STAFF RECOMMENDATION
2224 Blair Boulevard
April 18, 2018

Application: New construction – addition
District: Hillsboro-West End Neighborhood Conservation Zoning Overlay
Council District: 18
Map and Parcel Number: 10415014400
Applicant: Nick Dryden, DAAD Group
Project Lead: Jenny Warren, jenny.warren@nashville.gov

Description of Project: The applicant proposes to construct a rear addition.

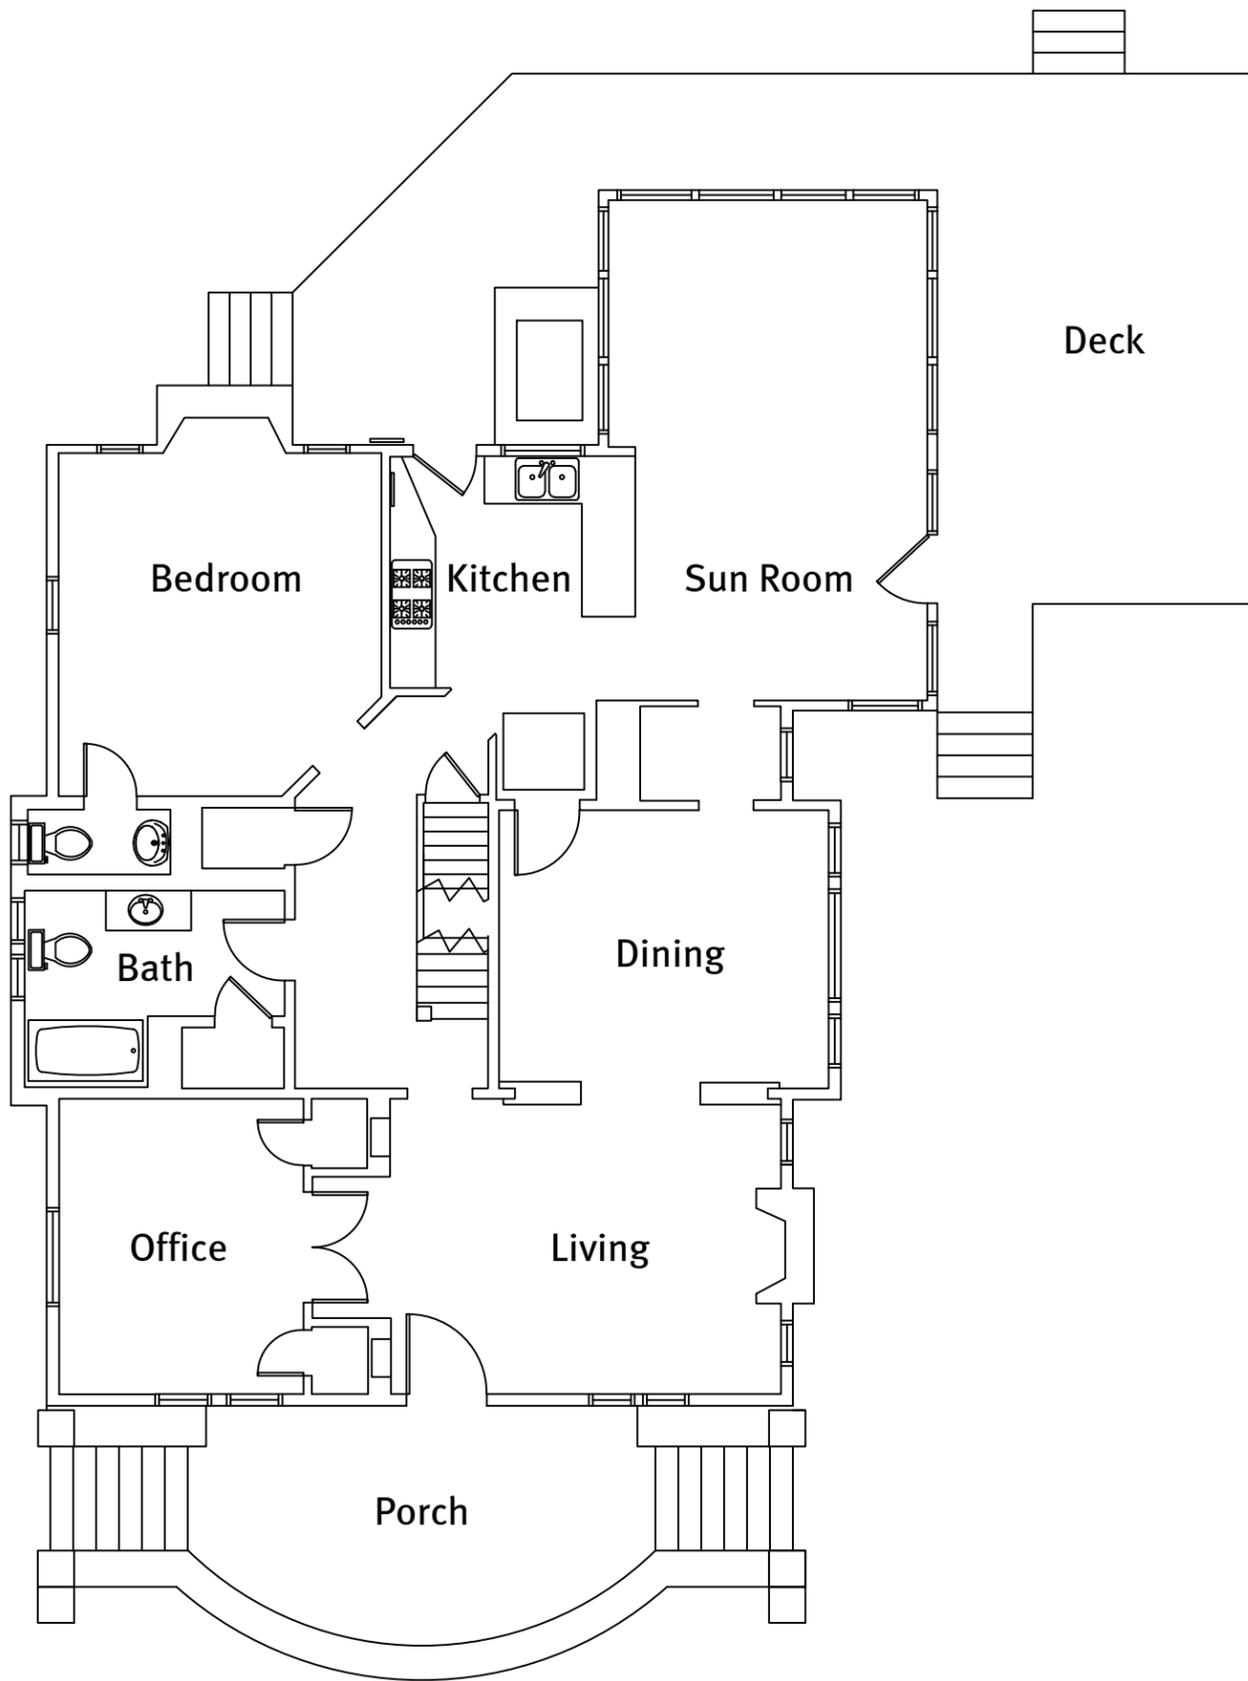
Roof form: The primary roof of the addition will be a rear-gable that ties into the roof form of the historic house seven inches (7") lower than the existing ridge. This primary rear gable will have a steeper pitch on the west side at about 7/12 and a shallower pitch on the east side at about 3/12. The gabled stair tower will have a 9/12 pitch, which matches the historic roof pitch. The roof of the one-story family room will have a very low slope, at about 2/12. The attached garage is discussed below under "Outbuilding." Overall, Staff finds the roofs of the proposed addition to be compatible with the existing building. The shallower roof slopes are appropriate because they are located in minimally visible locations and/or are porch roofs, which typically have lower slopes. Staff finds that the proposal meets section II.B.1.e of the design guidelines for roof form.

Proportion and Rhythm of Openings: The windows on the proposed addition are generally twice as tall as they are wide, thereby meeting the historic proportions of openings. The exception to this are the small square windows on the second floor of the east elevation. Staff finds that these smaller windows read as dormer windows and help to create a more one-and-a-half story appearance along this elevation. There are no large expanses of wall space without a window or door opening. At this time, there is no plan to replace the existing windows and doors, beyond the changes to the master bedroom windows on the west elevation, as discussed above. Staff finds the project's proportion and rhythm of openings to meet section II.B.1.g of the design guidelines.
